UNITED STATES PATENT AND TRADEMARK OFFICE

APPLICATION NO.	FILING DATE	FIRST NAMED INVENTOR	ATTORNEY DOCKET NO.	CONFIRMATION NO.
10/615,071	07/08/2003	Dirk J. Rettig	52.061	7880

Office Action Summary	Application No. 10/615,071	Applicant(s) RETTIG, DIRK J.	
	Examiner Vinh T Luong	Art Unit 3682

ATTACHMENT

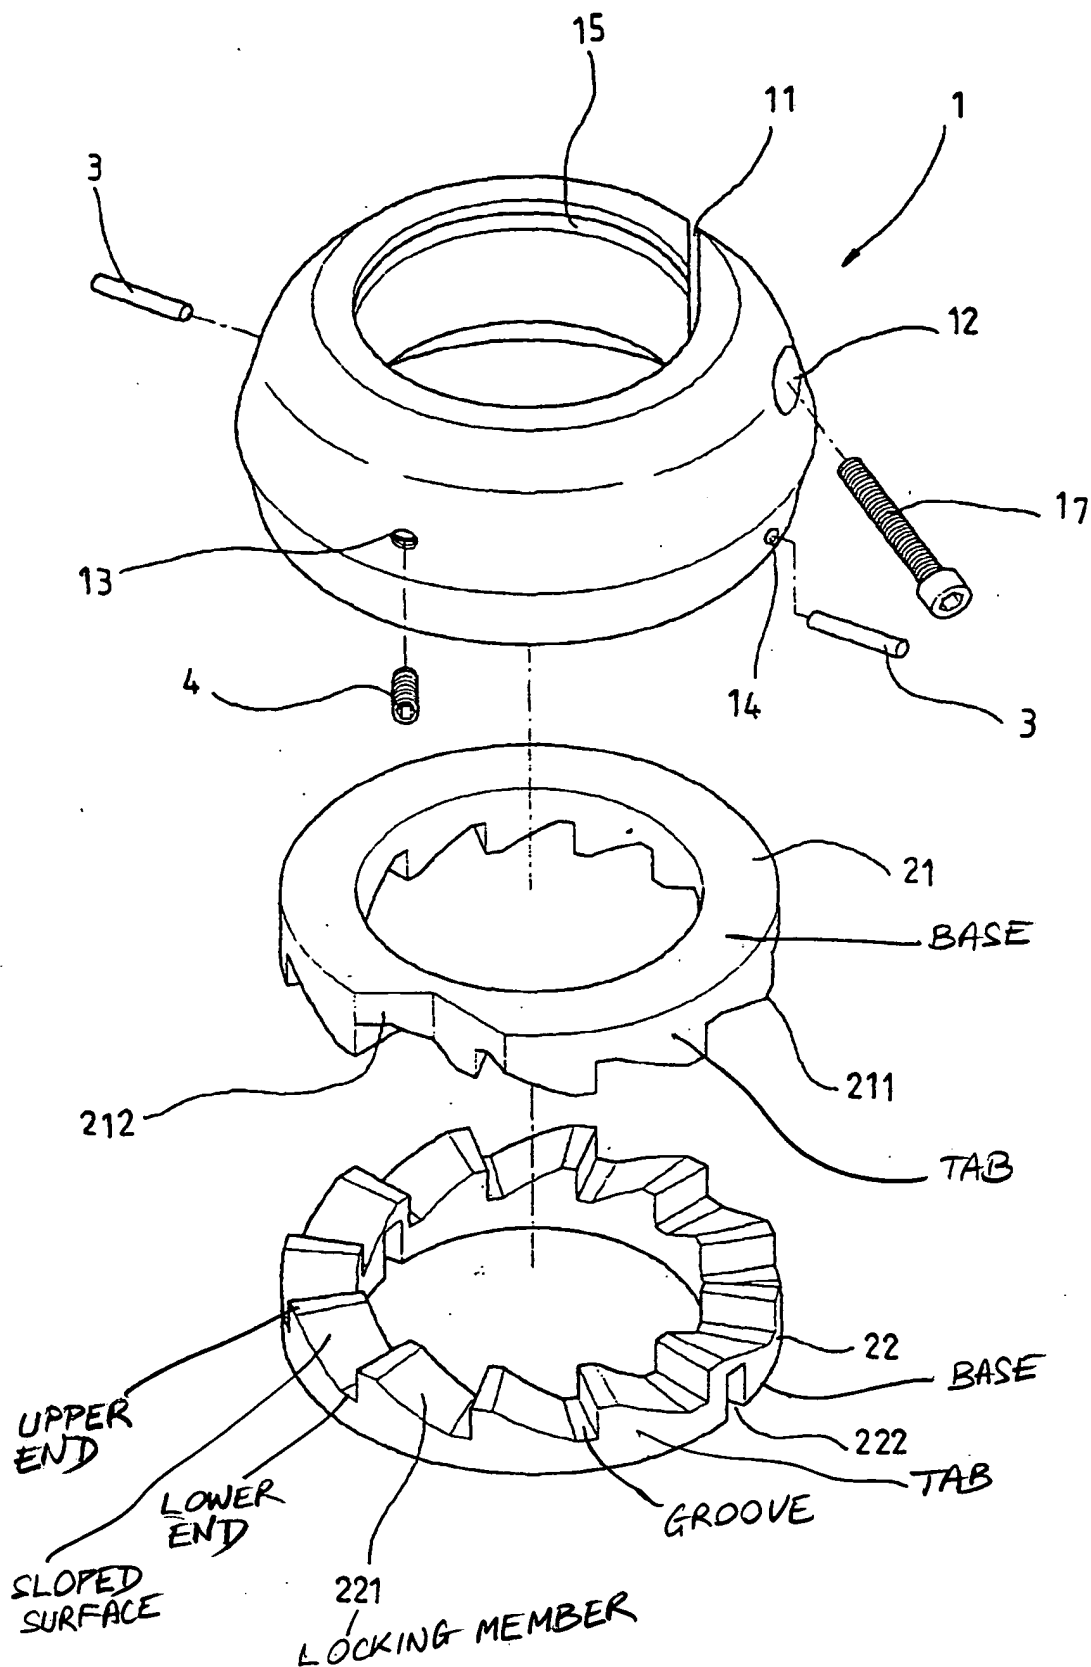
Regarding claim 1, Chi teaches a height adjustment assembly for a bicycle handlebar stem 91 that is positioned on a steer tube 8 of a bicycle, the height adjustment assembly comprising a first spacer (Fig. 1) *securable* to the steer tube 8 on one side of the stem 91 and including a first upper member 21 and a first lower member 22, each of the first upper member 21 and the first lower member 22 including a base (e.g., at 21 in Fig. 1. See Attachment) and a number of tabs (Att.) extending outwardly from one side of the base, each of the number of tabs

(Att.) including a plurality of locking members 221, 221 positioned on the tab (Att.), wherein the first upper member 21 is rotatable with respect to the first lower member 22 to selectively engage the locking members 211 on the first upper member 21 with the locking members 221 on the first lower member 22 in various configurations. See English translation.

Regarding claim 2, the base (Att.) is generally circular in shape.

Regarding claim 3, the number of tabs (Att.) is positioned in an abutting relationship with one another around the base (Att.).

Regarding claim 4, each of the number of tabs (Att.) has an upper end (Att.) and a lower end (Att.).

Regarding claim 5, each of the tabs (Att.) has a sloped surface (Att.) extending from the upper end (Att.) to the lower end (Att.).

Regarding claim 6, the plurality of locking members 211, 221 are disposed on the sloping surface (Att.).

Regarding claim 7, the plurality of locking members 211, 221 are formed as a number of teeth extending from each of the number of tabs (Att.) opposite the base (Att.).

Regarding claim 8, see a plurality of grooves (Att.) disposed between adjacent pairs of the number of teeth (Att.).
